**City Council Agenda Item #14\_  
Meeting of July 9, 2018**

Items concerning Ridgedale Executive Apartments located at 12501 Ridgedale Drive.

- 1) Rezoning from Planned I-394 District (PID) to Planned Unit Development (PUD);
- 2) Master development plan;
- 3) Final site and building plan

**MINNETONKA PLANNING COMMISSION**  
**June 14, 2018**

**SITE PLAN - BUILDING FOOTPRINT COMPARISON**

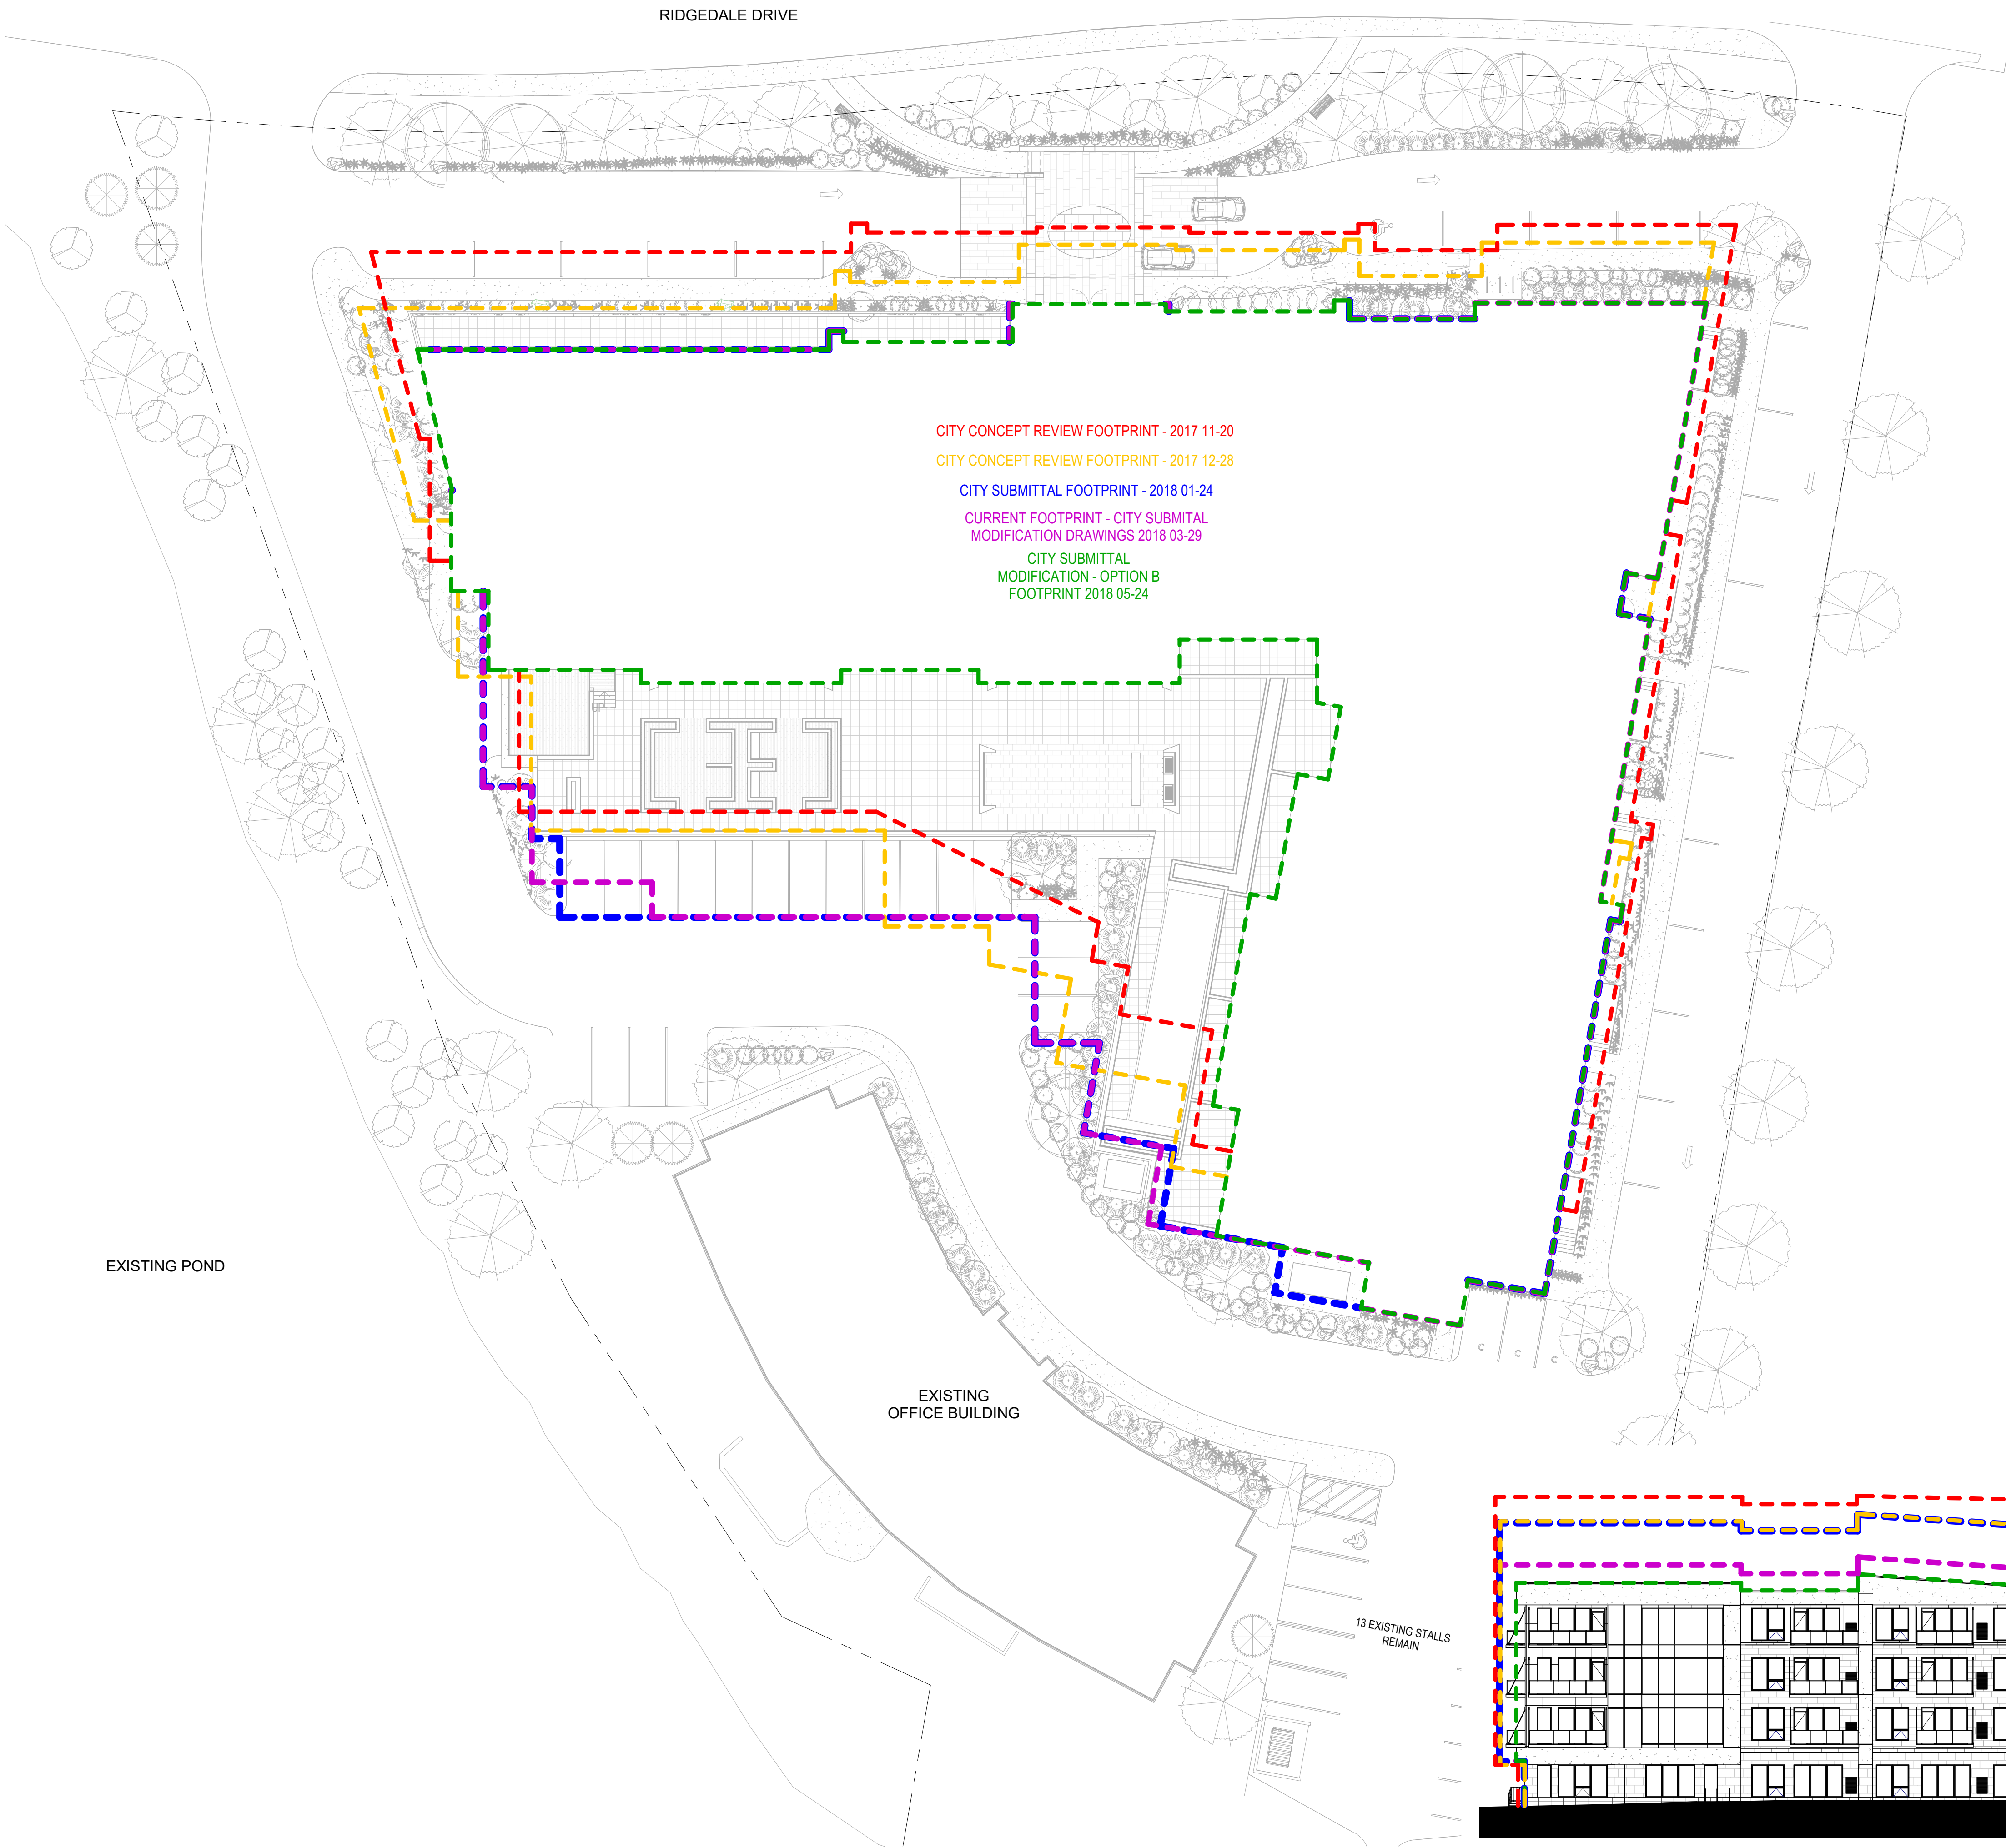
The applicant's revised building plans show an overall reduction in the building size from the original plans, mostly due to removal of the lower level parking garage. Comparisons of the original and revised plan sets of the building elevations are attached. The areas colored red represent the portions of the original plans that are removed in the revised plans.

The site plan has some minor changes, mostly to parking areas in the front and rear of the building. The front parking area changes from angled to parallel parking spaces west of the building entry. In the rear of the building, surface parking spaces replace the area previously occupied by the parking garage. The plan revisions include the following:

One of the primary project deficiencies from staff's review that remains unchanged from the original proposal is the lack of site organization. Site and building plan standards in city code call for "harmonious design for structures and site features." The tight "building behind building" approach for this site is one primary reason the project does not meet code standards. This is a basic urban planning and design principle that helps bring order to development. Intuitive and organized site design and building placement creates positive and productive environments. It is staff's opinion the organization of this site does not provide the necessary organizing principles that bring about harmonious design. As staff stated at the public hearing, the fact that the office building lacks visibility from Ridgedale Drive and does not have convenient access and parking supports the site and building plan review standards.

**NORTH ELEVATION - BUILDING HEIGHT COMPARISON**

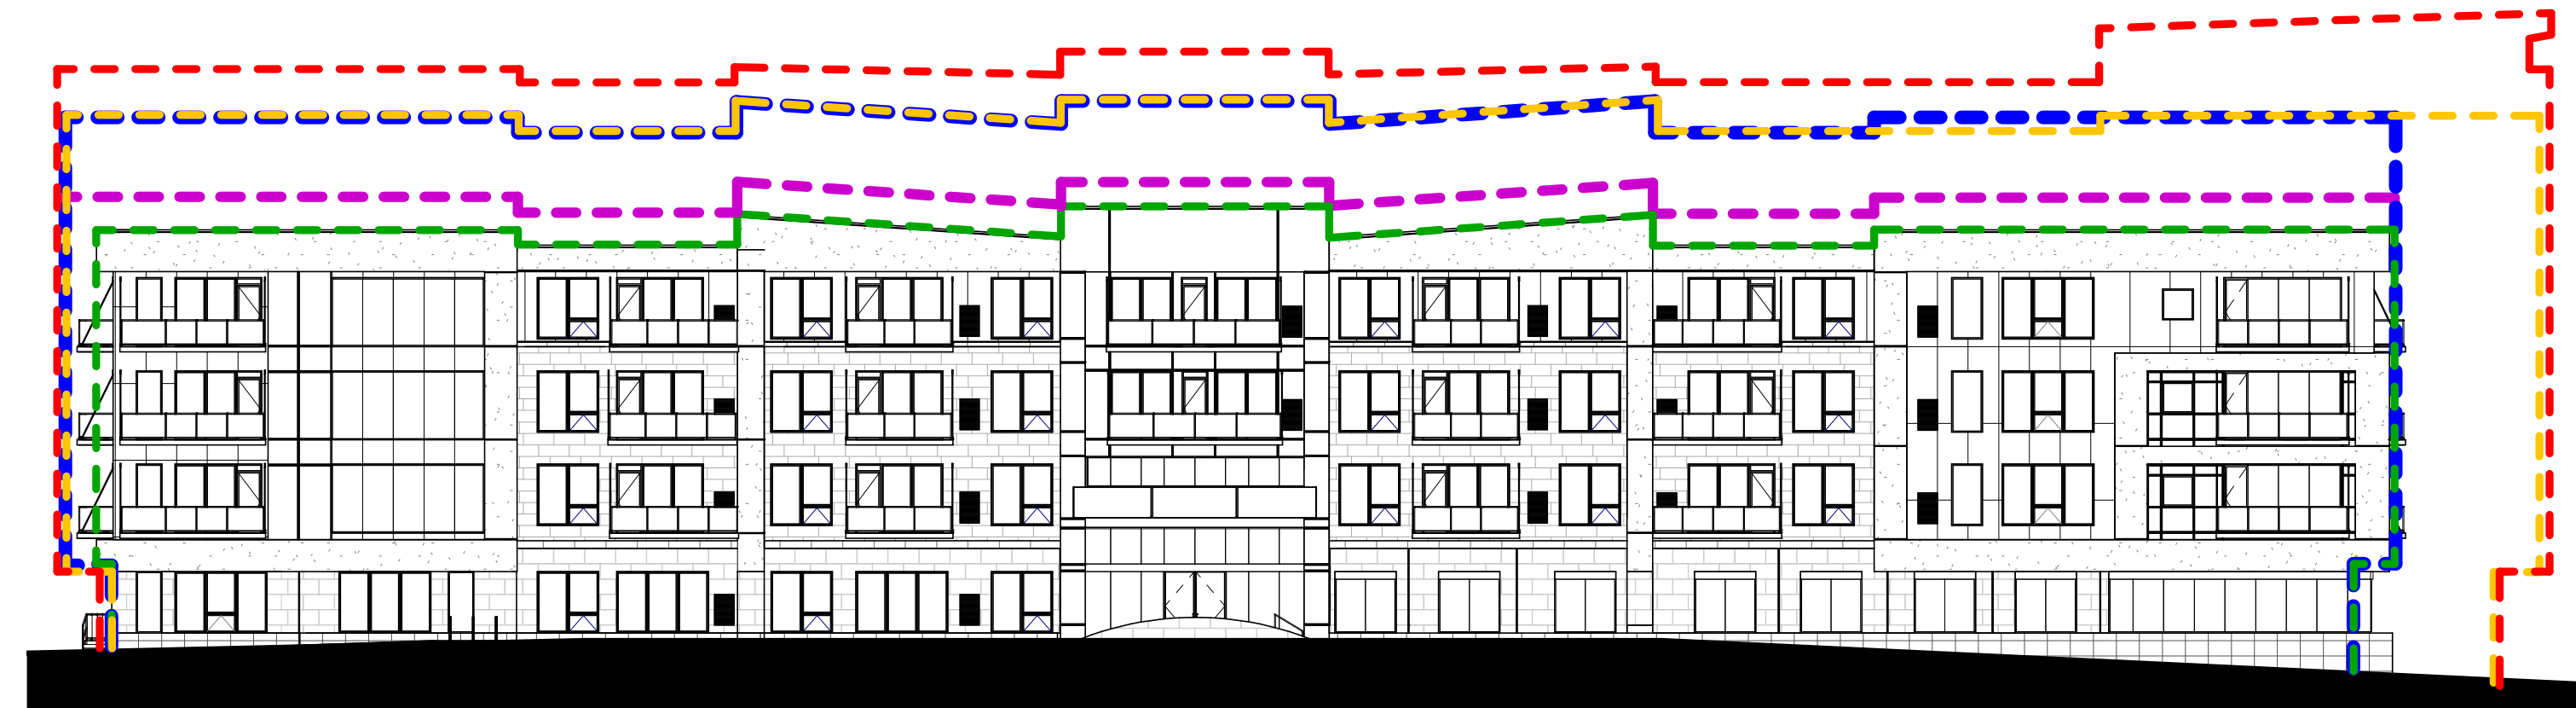
The revised plans do reduce the overall above grade building size by approximately 25,000 square feet. The living area of the building remains nearly the same, increasing by 318 square feet. Although the unit count increases by 1 unit (77 to 78), the bedroom count decreases by two (108 to 106).
